**1. Product type : A front loader washing machine**

**5. Exchanging parts : Tub outer, Heater assembly, Harness, Gasket**

**Subject : This changed parts number are changed to SVC after June, 2008 production lot.**

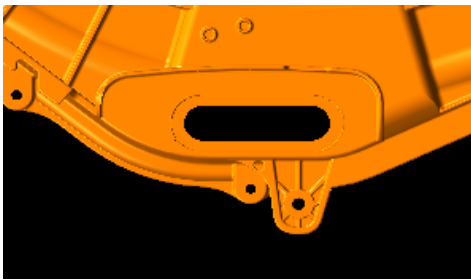
Before June., '2008	After Jube, '2008																		
<b>Tub Outer</b>	 <table border="1" data-bbox="249 934 743 1127"> <thead> <tr> <th></th> <th>Part Name</th> <th></th> </tr> </thead> <tbody> <tr> <td>①</td> <td>Tub,Outer</td> <td>3044ER0007A 3044ER0007G</td> </tr> <tr> <td>②</td> <td>Gasket</td> <td>4036FR4050A</td> </tr> </tbody> </table>		Part Name		①	Tub,Outer	3044ER0007A 3044ER0007G	②	Gasket	4036FR4050A	 <table border="1" data-bbox="786 938 1358 1087"> <thead> <tr> <th></th> <th>Part Name</th> <th>P/No.</th> </tr> </thead> <tbody> <tr> <td>①</td> <td>Tub,Outer</td> <td>3044ER0007H</td> </tr> <tr> <td>②</td> <td><del>Gasket</del></td> <td>nondiscrimination</td> </tr> </tbody> </table> <p style="text-align: center;">   <b>Remove</b> </p>		Part Name	P/No.	①	Tub,Outer	3044ER0007H	②	<del>Gasket</del>	nondiscrimination
	Part Name																			
①	Tub,Outer	3044ER0007A 3044ER0007G

②	Gasket	4036FR4050A																		
	Part Name	P/No.																		
①	Tub,Outer	3044ER0007H																		
②	<del>Gasket</del>	nondiscrimination																		
<b>Heater Assembly</b>																				
<b>Harness</b>	 	  <p style="text-align: right; color: green;">Housing change</p>

After 1<sup>st</sup>. June 2008 the old Tub outer, Heater and Harness will not produce anymore except bellow case.

1. If you need to change **Tub Outer** have to use new **Heater assembly and Main Harness.**

Because new Tub outer doesn't assembly to old Harness and Heater assembly.

2. If you need to change **Harness assembly** have to use new **Heater assembly.**

Because new Harness doesn't assembly to old Heater assembly.

3. If you need to change **Heater assembly. Not change the other Part.**
